Subject: **Docket Nos. 50-361 and 50-362
Proposed Change Number NPF-10/15-514
Increase in Reactor Power to 3438 MWt
San Onofre Nuclear Generating Station
Units 2 and 3**

**DESCRIPTION AND NO SIGNIFICANT HAZARDS ANALYSIS
FOR PROPOSED CHANGE NPF-10/15-514
San Onofre Nuclear Generating Station Units 2 and 3**

Proposed Change Number 514 is a request to revise the licensed Rated Thermal Power (RTP) for the San Onofre Nuclear Generating Station (SONGS), Units 2 and 3, from the originally licensed rating of 3390 MWt to 3438 MWt.

Figure 2-1, Block Diagram

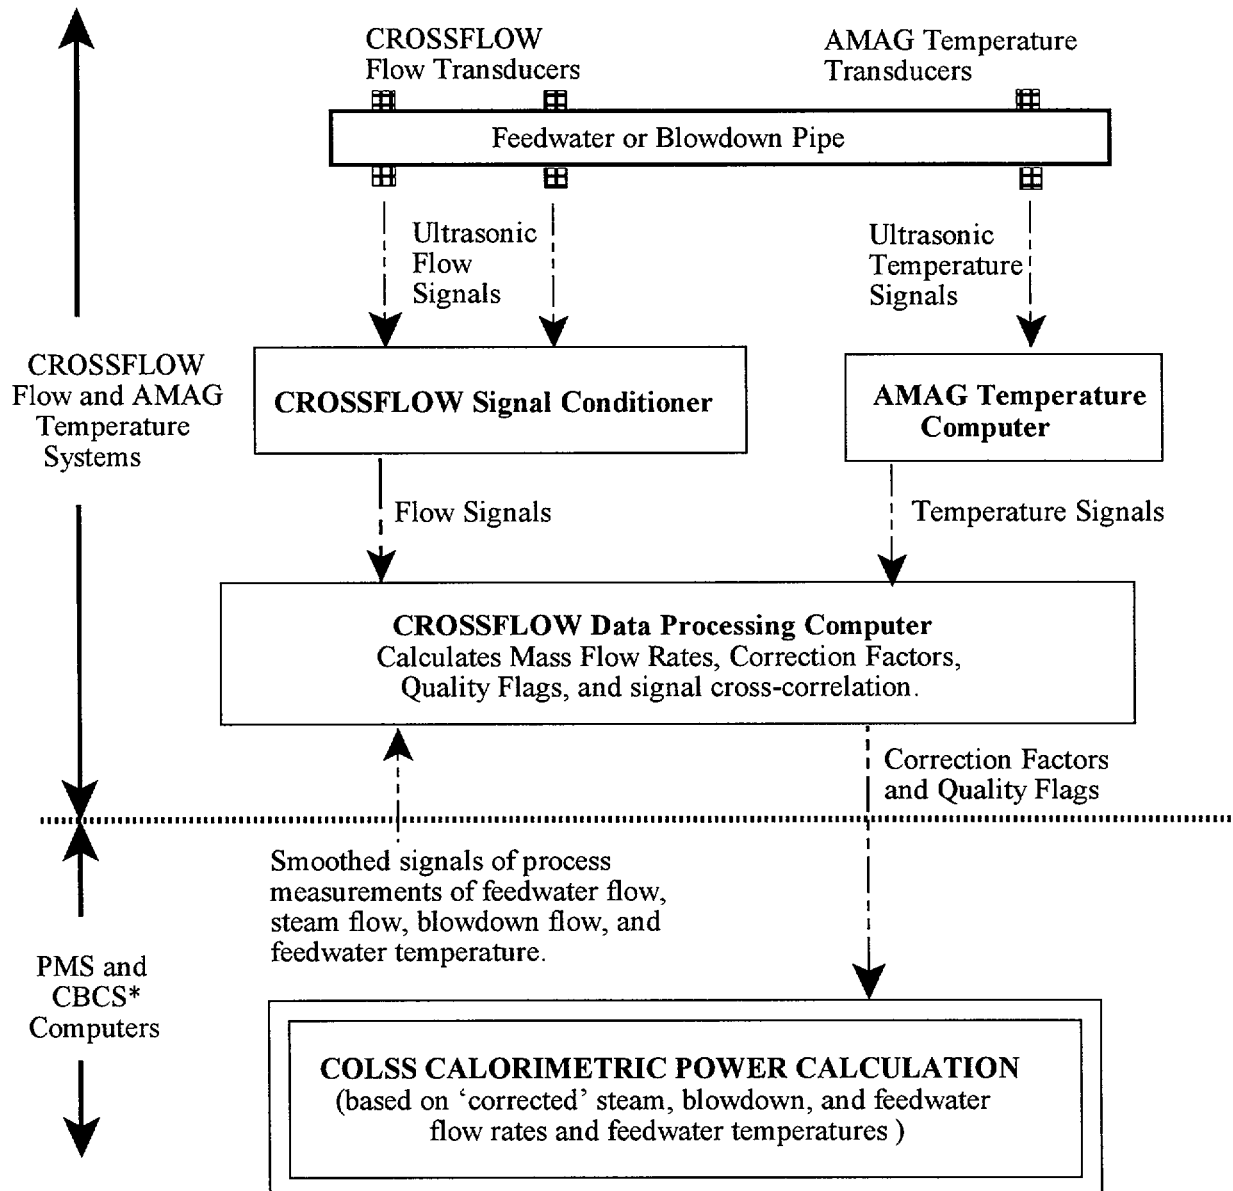
The Westinghouse CROSSFLOW (reference 8.5) ultrasonic flow measurement system (UFM) is used in conjunction with the AMAG high-accuracy ultrasonic temperature measurement system (UTM) and two plant process computers, the Plant Monitoring System (PMS) and Core Operating Limit Supervisory System (COLSS) Backup Computer System (CBCS), to support the increase in reactor power (see Figure 2-1). Reactor power is calculated in COLSS, which resides in the PMS and CBCS plant process computers, from values (including feedwater flow, feedwater temperature, steam flow, and blowdown flow) that are based on corrections from the CROSSFLOW system. The components and information flow path are shown in Figure 2-1, "Block Diagram of SONGS Ultrasonic Systems and Computers."

Cables from ultrasonic flow and temperature sensors will be routed to signal conditioning equipment and data processing computers located in a non-harsh area. The functions of the CROSSFLOW flow signal conditioning equipment and data processing computer are described in the Topical Report (reference 8.5).

The data processing computer receives smoothed values of process measurements of main feedwater flow, main feedwater temperature, main steam flow, and blowdown flow for each loop from the PMS and CBCS. The data processing computer calculates main steam flow for each steam generator from the difference between the ultrasonically-determined feedwater and blowdown flow rates for that generator. The data processing computer compares long-duration averages of the process measurements to long-duration averages of the ultrasonically-determined flows and temperatures, and produces correction factors for feedwater flow, feedwater temperature, blowdown flow, and main steam flow. The data processing computer also determines if each correction factor is sufficiently valid for use and, if valid, sets its quality flag to "good."

The data processing computer then sends the correction factors and quality flags to the PMS and CBCS. If the quality flags are "good" and the plant is above a minimum power level, the COLSS programs in each computer multiply plant process signals of feedwater flow, feedwater temperature, blowdown flow, and main steam flow by their associated correction factors to produce corrected process values. COLSS then uses the "corrected process values" to calculate reactor power and allows operation up to 3438 MWt. Two separate plant computers, PMS and CBCS, are available to calculate reactor power in COLSS. Under our current COLR values for Linear Heat Rate (LHR) and Departure from Nucleate Boiling Ratio (DNBR), a COLSS out of service condition may preclude full power operation based on Core Protection Calculator (CPC) operating margin.
